Project	<b>IEEE 802.16 Broadband Wireless Access Working Group</b> < <a href="http://ieee802.org/16">http://ieee802.org/16</a> >	
Title	<b>Preamble sequence for supporting scalable FFT</b>	
Date Submitted	<b>2004-07-08</b>	
Source(s)	Jiho Jang, Jeongheon Kim, Seungjoo Maeng, Panyuh Joo, Jaeho Jeon, Soonyoung Yoon	<a href="mailto:jiho.jang@samsung.com">jiho.jang@samsung.com</a> <a href="mailto:jeongheon.kim@samsung.com">jeongheon.kim@samsung.com</a> <a href="mailto:sjmaeng@samsung.com">sjmaeng@samsung.com</a> <a href="mailto:panyuh@samsung.com">panyuh@samsung.com</a> <a href="mailto:jhjeon@samsung.com">jhjeon@samsung.com</a> <a href="mailto:soon.young.yoon@samsung.com">soon.young.yoon@samsung.com</a>
	Samsung Electronics Co., Ltd. Dong Suwon P.O.Box 105 416, Maetan-3dong, Yeongtong-gu, Suwon-city, Gyeonggi-do, Korea 442-600	
Re:		
Abstract	Preamble sequences for FFT size other than 2048-FFT	
Purpose	Adopting of proposed method into P802.16e

## Preamble sequence for supporting scalable FFT

**Figure aaa – Preamble sequence generator for 128-FFT**

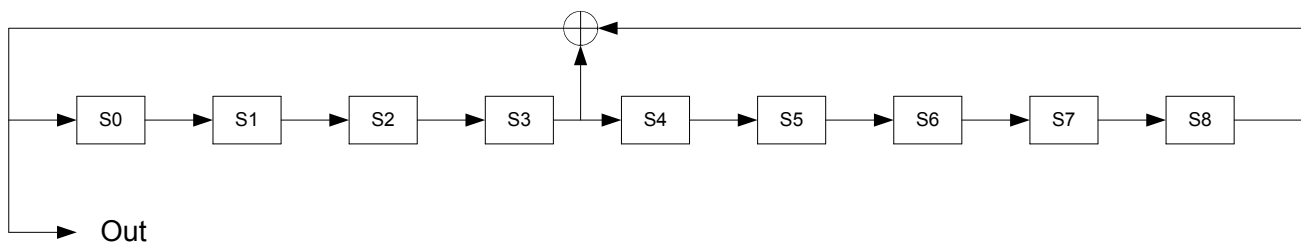
For the FFT size of 128-FFT, the preamble sequences can be generated using the shift register structure in figure aaa where the initial state value are defined in table xxx. The first k elements of output sequence are used for a preamble, where k is the number of carriers.

Figure bbb – Preamble sequence generator for 512-FFT

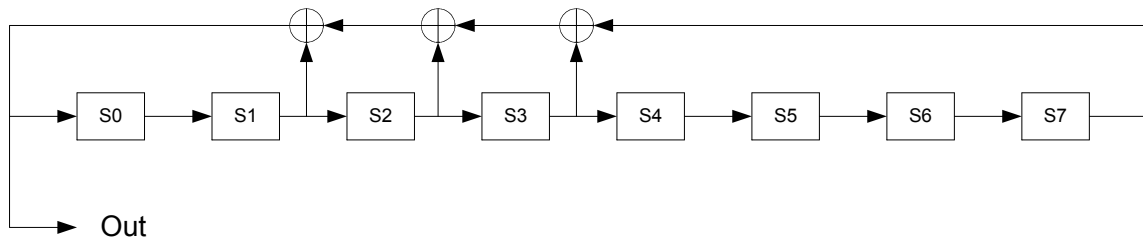
For the FFT size of 512-FFT, the preamble sequences are generated using the shift register structure in figure bbb where the initial state value are defined in table yyy. The first k elements of output sequence are used for a preamble, where k is the number of carriers.

Figure ccc – Preamble sequence generator for 1024-FFT

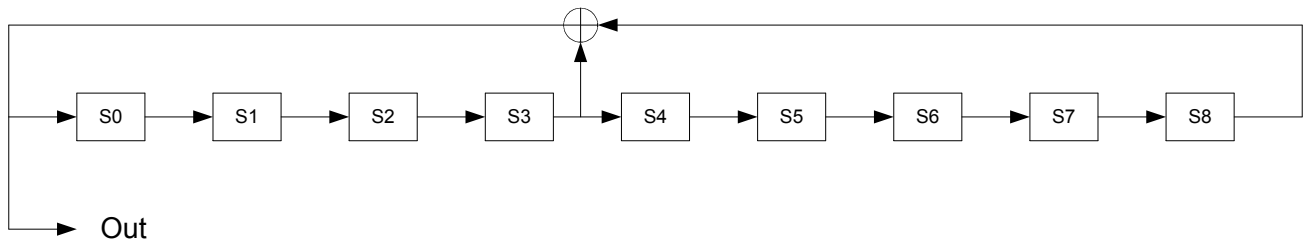
For the FFT size of 1024-FFT, the preamble sequences are generated using the shift register structure in figure ccc where the initial state value are defined in table zzz. The first k elements of output sequence are used for a preamble, where k is the number of carriers.
